AWC DATABASE CATALOG/ATLAS CORRECTION FORM

Map: Kenai B-6

Water Body Number: 246-20-10020-2010

Describe Change(s): revise hydrography & reposition lower pt

Kenai
B- 6

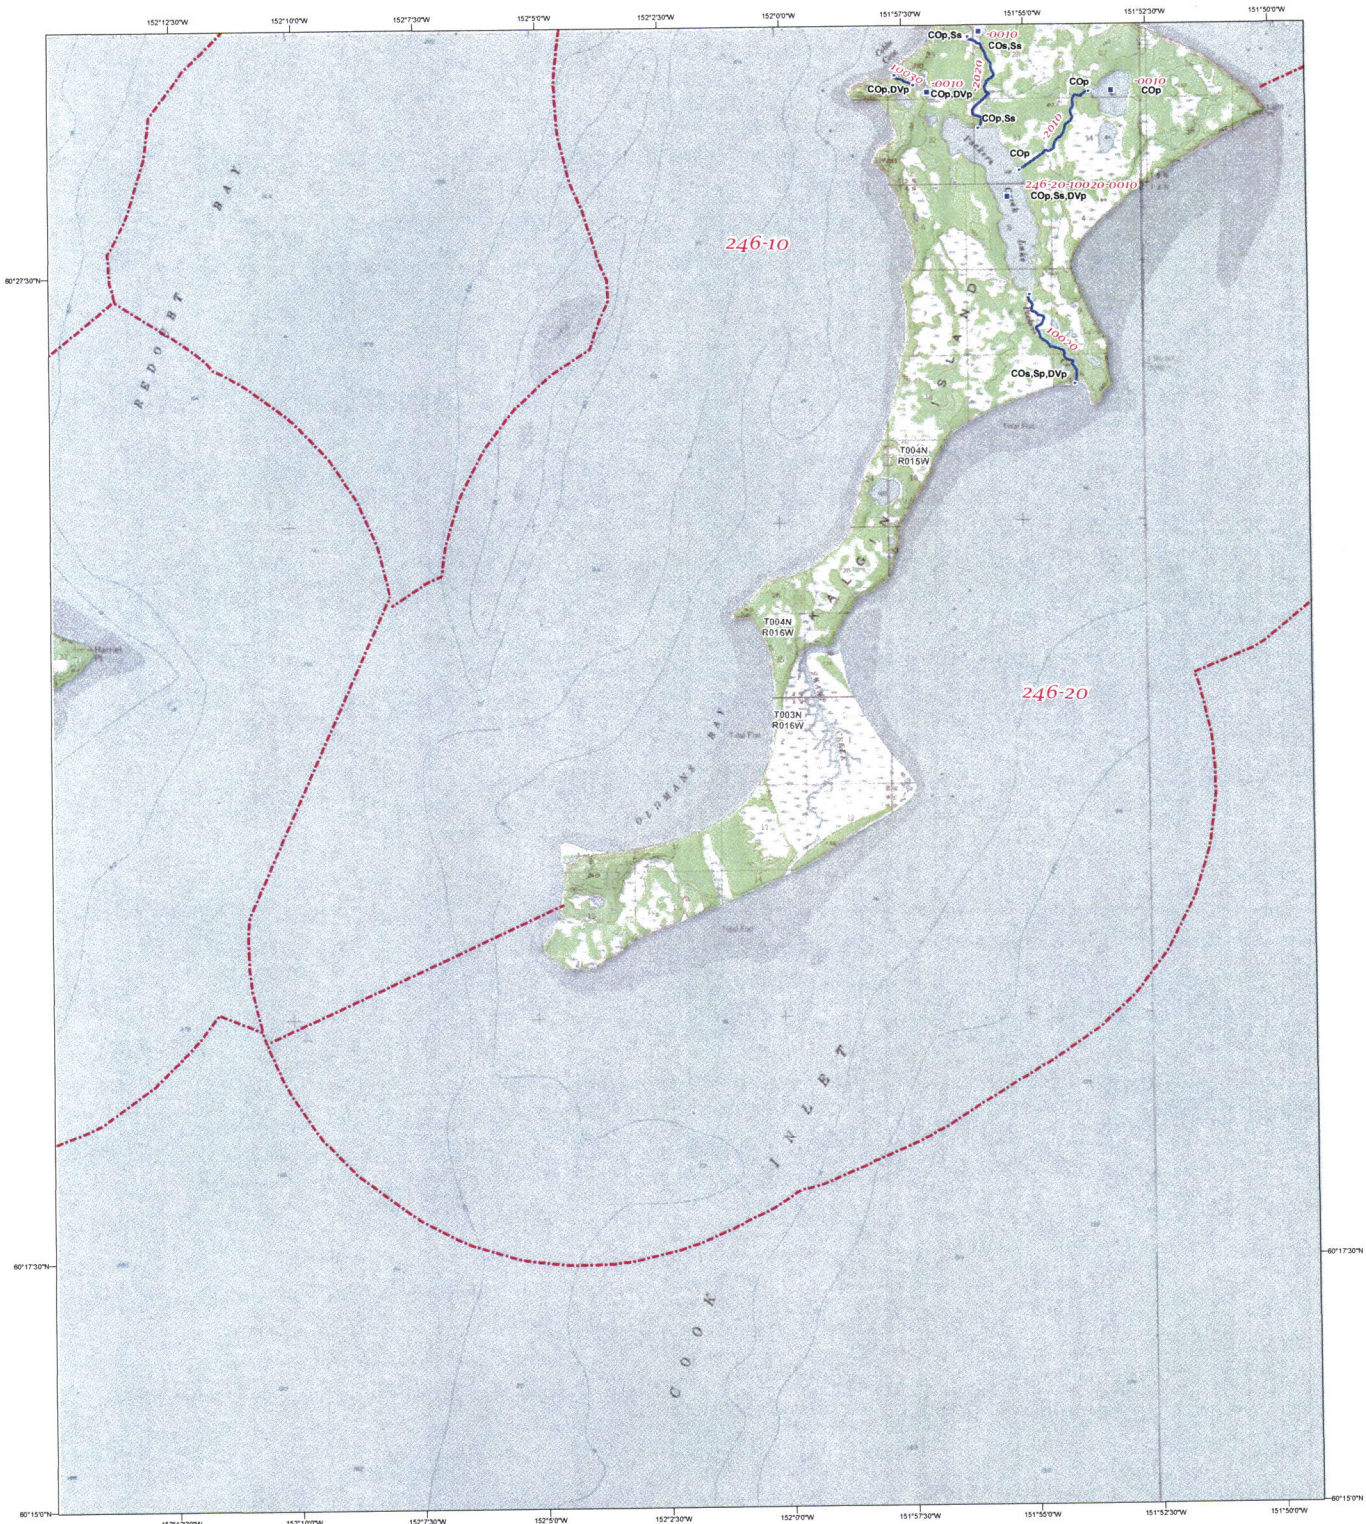
reposition lower pt to -151.9249 60.4797
rvise hydrography w/NHD flowline
for 246-20-10020-2010

Not sure you are the right person for this, but if not, I'm sure you can forward to the right person. Have identified what appears to be a miss-plotted portion of an anadromous stream on Kalgin Island. Have attached two maps, one (ADFG KENB6 mark-up) shows the line segment in question and the other (Google Physical Map mark-up) shows what may be the correct stream course.

This came to light because the stream-segment that appears to be miss-plotted does not show on the topographic base map used for the ADFG Atlas Map (KENB6) and the stream is one we need to deal with in the KPB preliminary municipal land conveyance decision currently being worked on. I did find the stream on the Google Physical Map that is available in DNR's New Mapper which allowed me to indicate where it appears the stream should be plotted.

Thx for bringing this to the dept's attn.
Your query regarding hydrography for AWC# 246-20-10020-2010 was forwarded to me.
A review of USGS NHD and Bing Orthoimagery does indicate that stream arc positioning should be revised.
Are you familiar enough w/ADF&G nomination process to submit a revision?
If not, dept staff can.
Dept is accepting updates to AWC dB thru Sept 29th, changes made this cycle, will be reflected on revised maps which are scheduled to become regulatory June 1, 2013.
